Product Change Notice (PCN)

PCN Number: **PCN-0454705R-02**

Product(s) Affected: **UJ2-BV-1-TH**

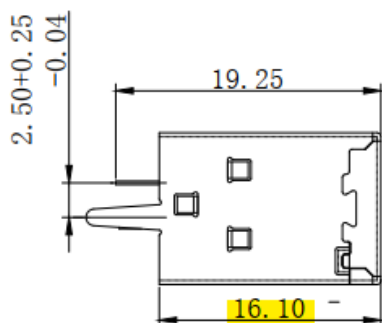
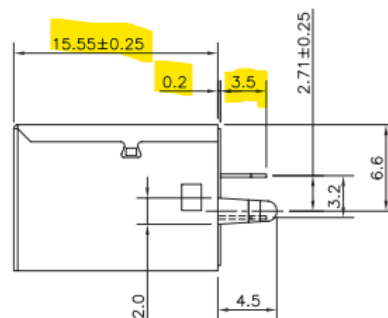
Description of Change: **New Factory Location. Product optimized for improved production yield and board fit. Minor housing difference. Insulator plastic color changed from black to white. Longer legs, taller body, and shorter pin lengths. The leg shape has more exaggerated crimp for a more secure board fit. PCB footprint is equivalent in function and layout. Operating temp range improved. Current capacity increased from 1 amp to 1.5 amp. Insertion force decreased from 35N to 30N. Additional changes in measurements listed.**
